Florida Department of
Environmental Protection
Inspection Checklist

Facility Name: SOUTHEAST COUNTY SLF (PICNIC LF)

On-Site Inspection Start Date: 09/02/2010

Active Area, Section 9

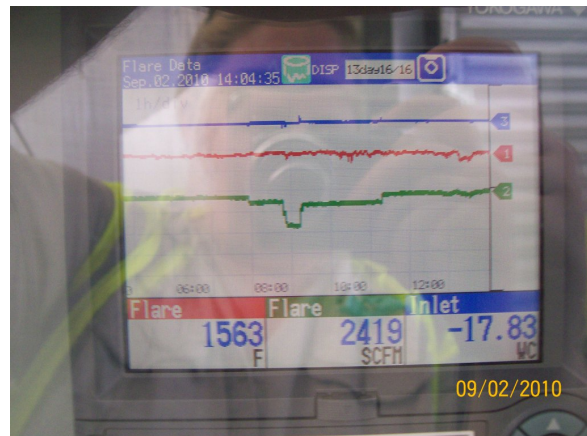
Item 2.22 - During the inspection, Department staff arrived at the PPS-A and the high level alarm light had been activated. Operator indicated they had recently been having electrical issues with the floats.

The Section 9 Pump Station also indicated an electrical problem, showing error message, "over amp".

Please provide additional information about the problems and any subsequent repairs.
